# Product / Process Change Notification

N° 2017-008-A

## Capacity extension for dedicated OptiMOS™ products in PG-TDSON package at Infineon Technologies Wuxi Co., Ltd., China

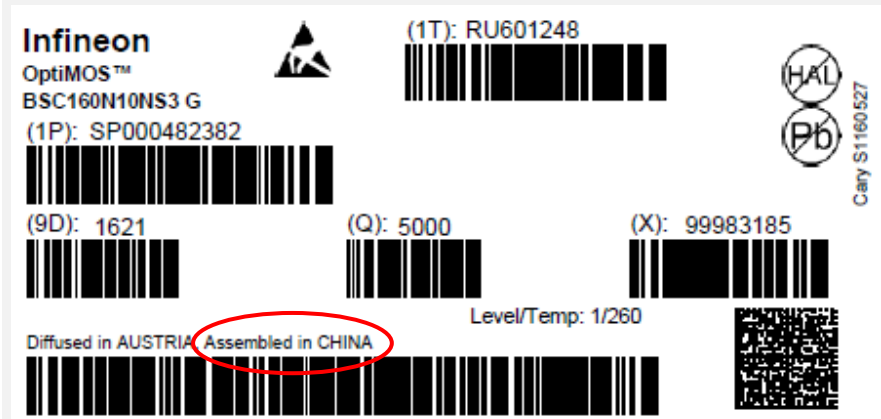
<b>Description:</b>	<u>Old</u>	<u>New</u>
<b>Assembly and Final Test location:</b>	<ul style="list-style-type: none"> <li>Infineon Technologies Melaka Sdn. Bhd., Malaysia</li> </ul>	<ul style="list-style-type: none"> <li>Infineon Technologies Melaka Sdn. Bhd., Malaysia</li> </ul> <p>and</p> <ul style="list-style-type: none"> <li>Infineon Technologies Wuxi Co., Ltd., China</li> </ul>
<b>Mould compound:</b>	<ul style="list-style-type: none"> <li>Hitachi CEL 1772</li> </ul>	<ul style="list-style-type: none"> <li>Hitachi CEL 9240 (IFX MAL and IFX Wuxi)</li> </ul>
<b>Marking on device:</b>	<ul style="list-style-type: none"> <li>No underline on the first letter at the date code</li> </ul> 	<ul style="list-style-type: none"> <li>Underlined first letter of date code for assembly fab Wuxi</li> </ul>
